SUBJECT: Transmittal of a Correction to the Approved Explosives Safety Submission,  
Ordnance and Explosives Removal Action for the Proposed Eastern Bypass at  
Fort McClellan, AL

SUBJECT: Correction to the Approved Conventional Explosives  
Safety Submission, Ordnance and Explosives (OE) Removal Action,  
Eastern Bypass, Fort McClellan, Alabama

Figure 3  
**Q-D Map**

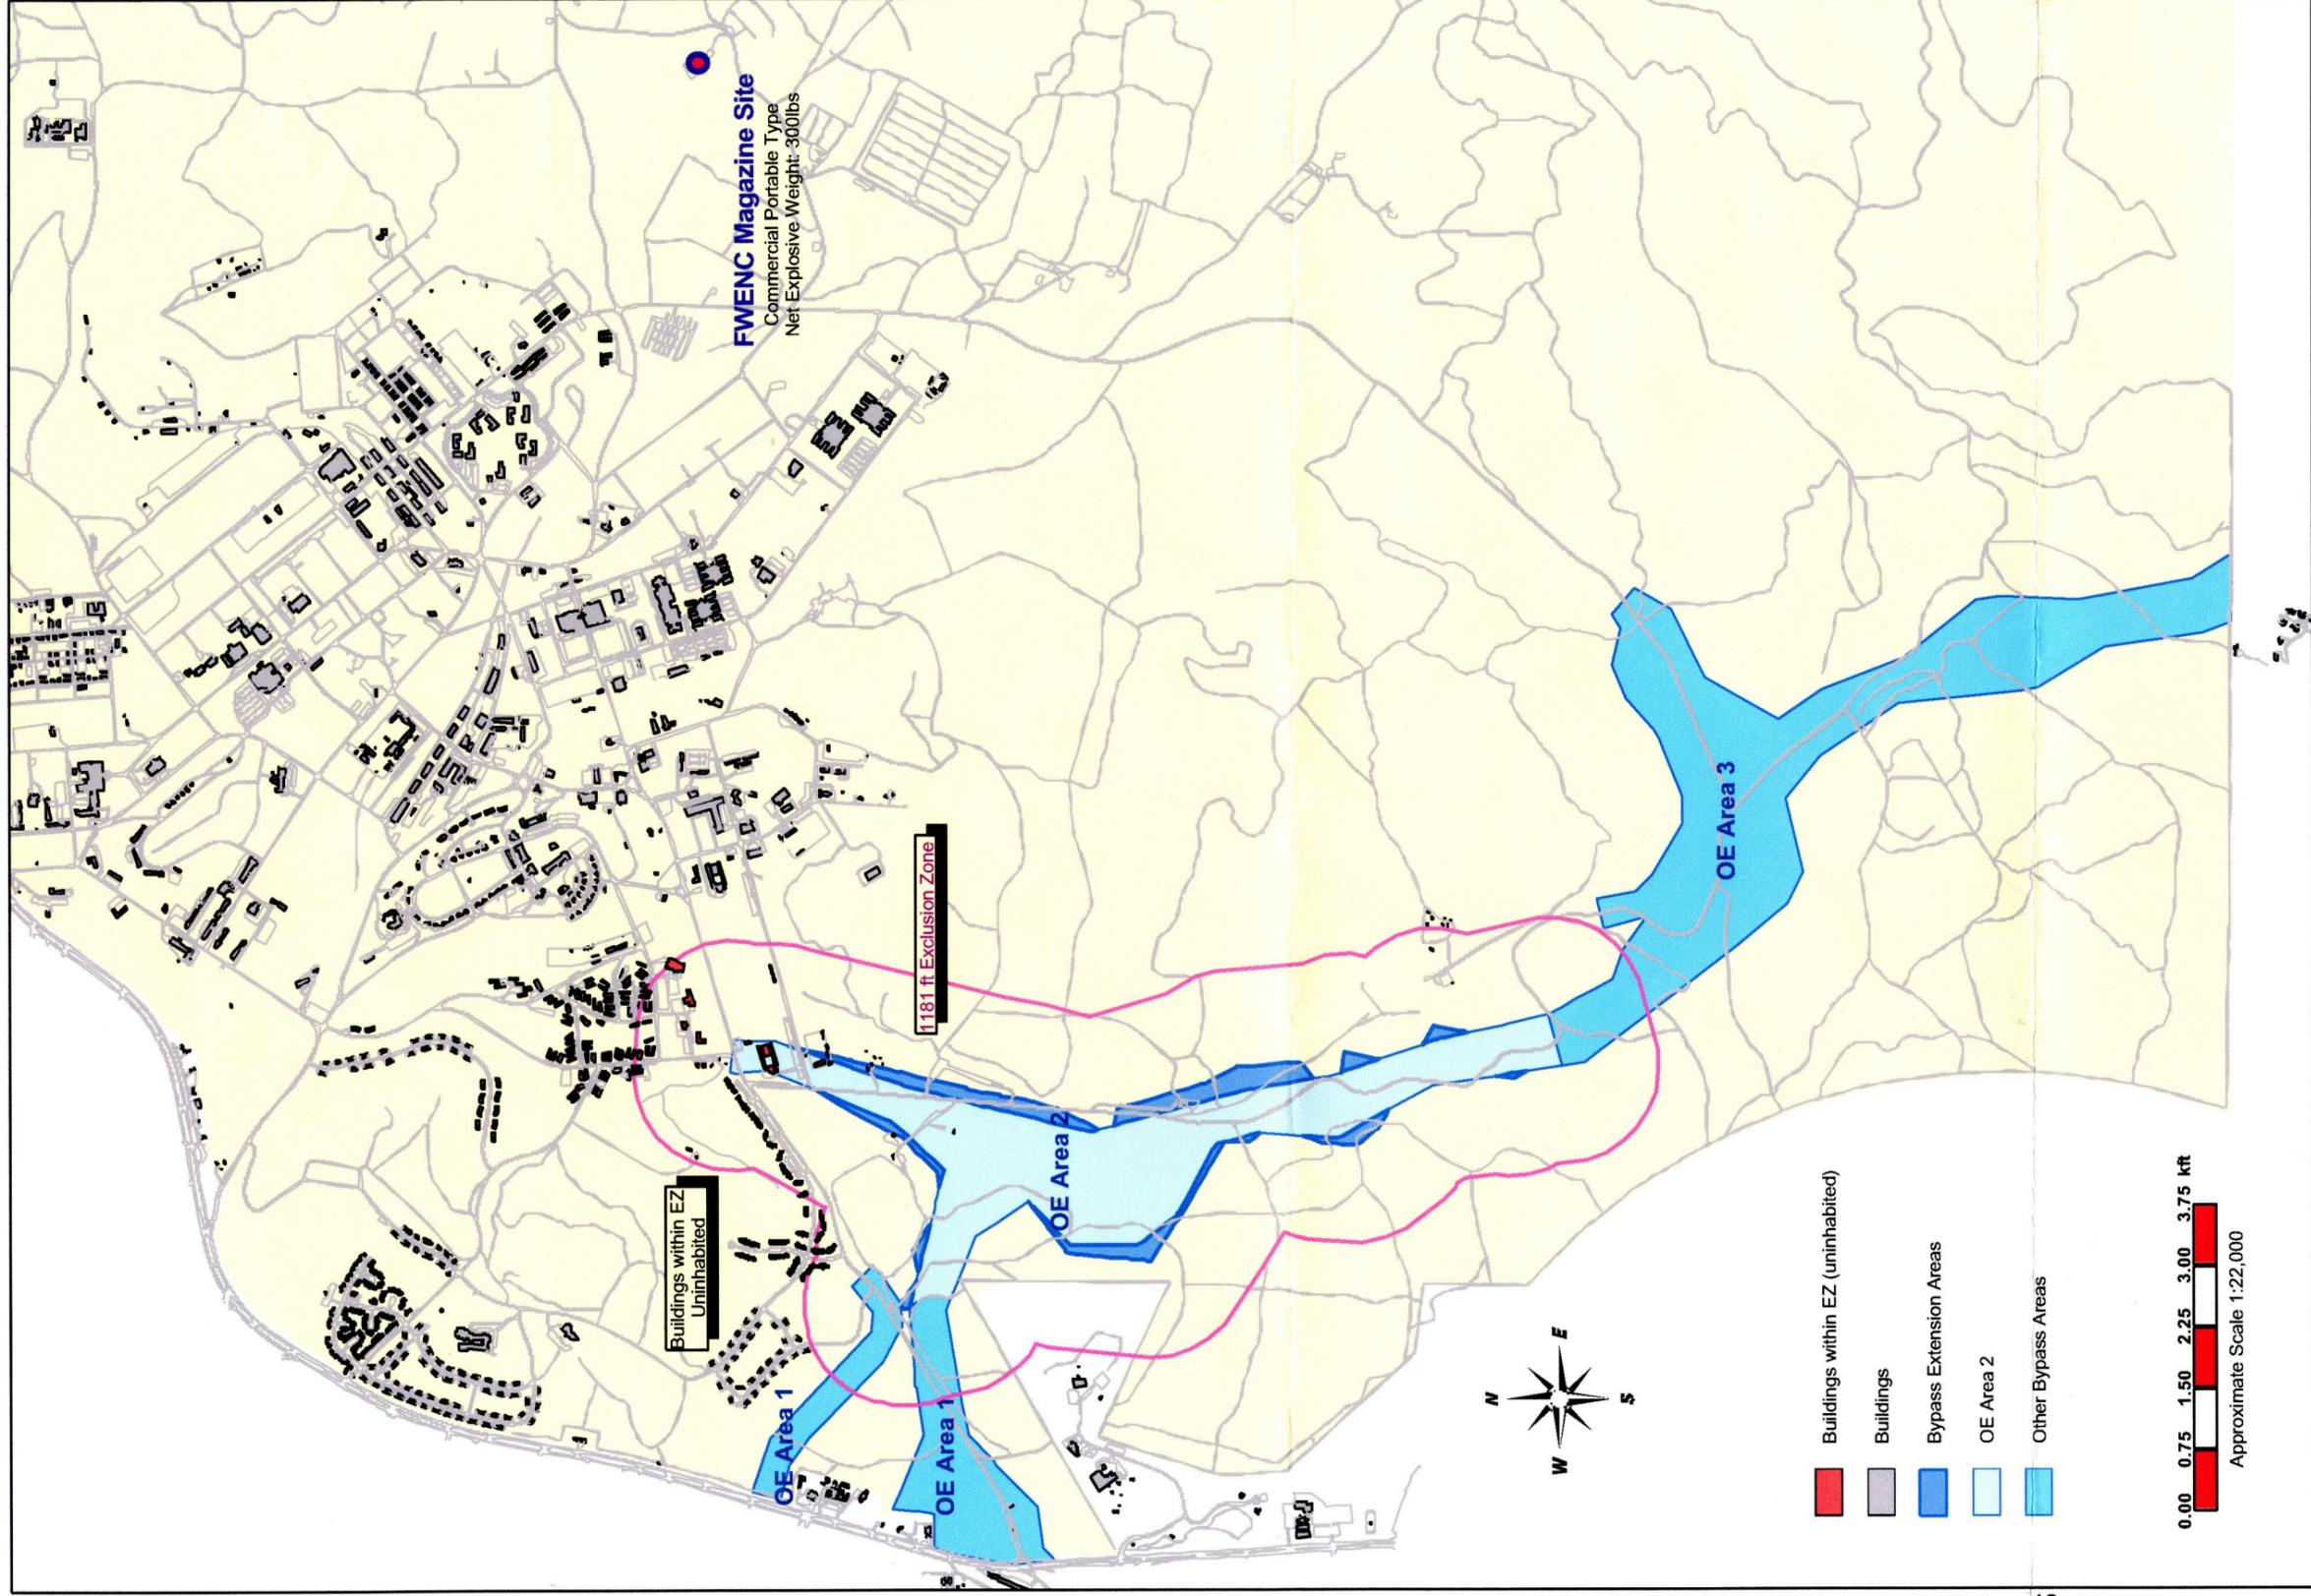
a. A new figure 3, Q-D Map for OE area 2 is enclosed. This change is brought about by the addition of approximately 40 acres of land requiring OE removal being added to OE area 2.
